November 6, 2015

Subject: RESPONSE PACIFIC GAS AND ELECTRIC COMPANY'S PETITION  
FOR RECONSIDERATION OF THE WATER QUALITY CERTIFICATION  
FOR THE DESABLA-CENTERVILLE HYDROELECTRIC PROJECT

Figure 1: Exceedance plot showing measured hydrology below Hendricks Head Dam. This plot shows high flows experienced at this location on the y-axis.

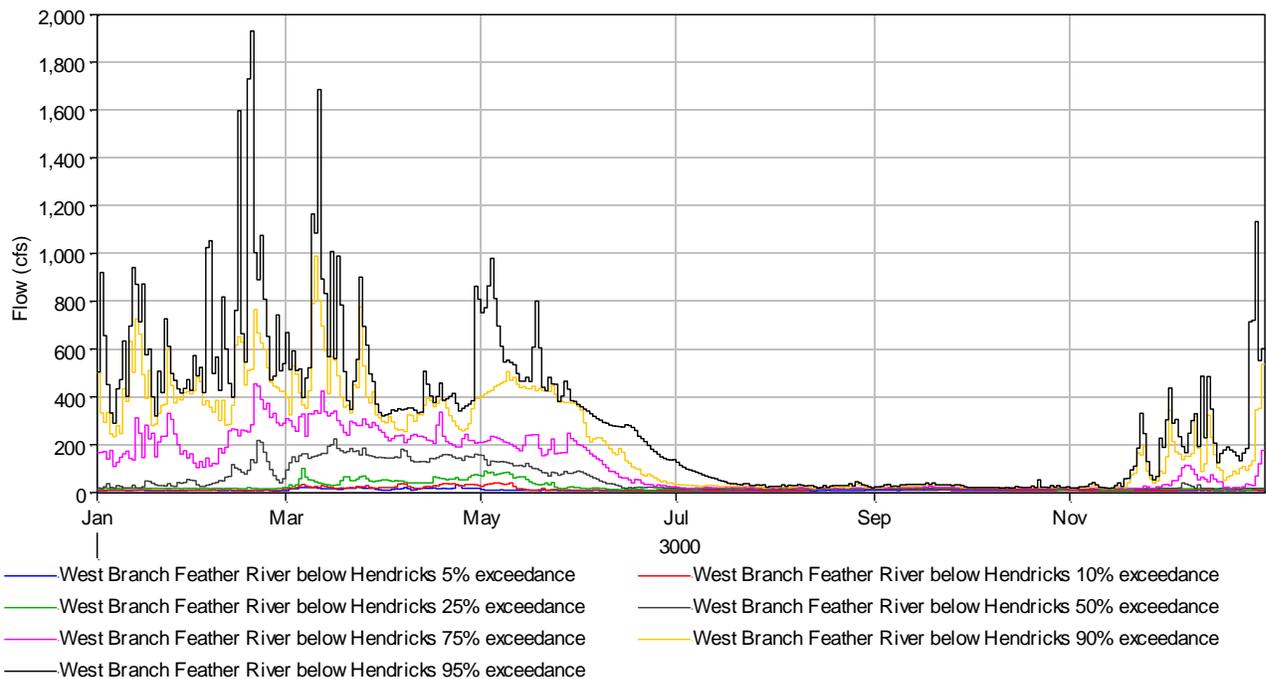
An exceedance analysis of 30 years of observed flows at this location illustrates that flows below Hendricks Head Diversion Dam routinely exceed the mapping flow of 24 cfs, with daily averages ranging up to 1890 cfs. Even in some of the driest (5% exceedance) days on record, flows can exceed the mapped levels during springtime. In the median condition (50% exceedance) flows exceed 24 cfs for all of February through mid-May. At these higher flows, the low-flow passage barriers may have significantly higher downstream water surface elevation, which can make passage over barriers much easier. Additionally, at these high flows, multiple flow pathways would open up, which can provide more passage opportunities for fish.

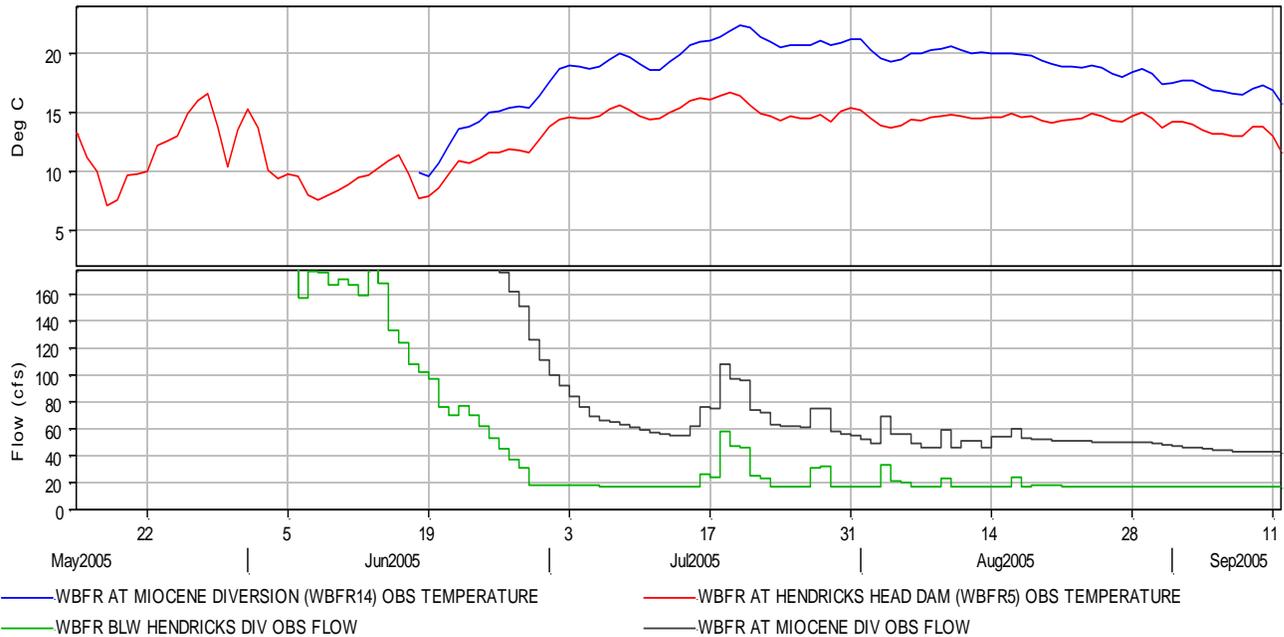
Trout will use these higher flows to move opportunistically through more difficult barriers when conditions are appropriate. For example, temperature data from 2005 collected on the West Branch Feather River shows that daily average temperatures above Miocene Diversion started to reach 20°C around July 7. At this time, flows in the reach below Hendricks were about 17 cfs at the top of the reach (below Hendricks), and 65 cfs at the bottom of the reach at the Miocene diversion. However, within the next week, storm flows increased flows to 58 cfs at the top of the reach, and 108 cfs at the bottom of the reach.
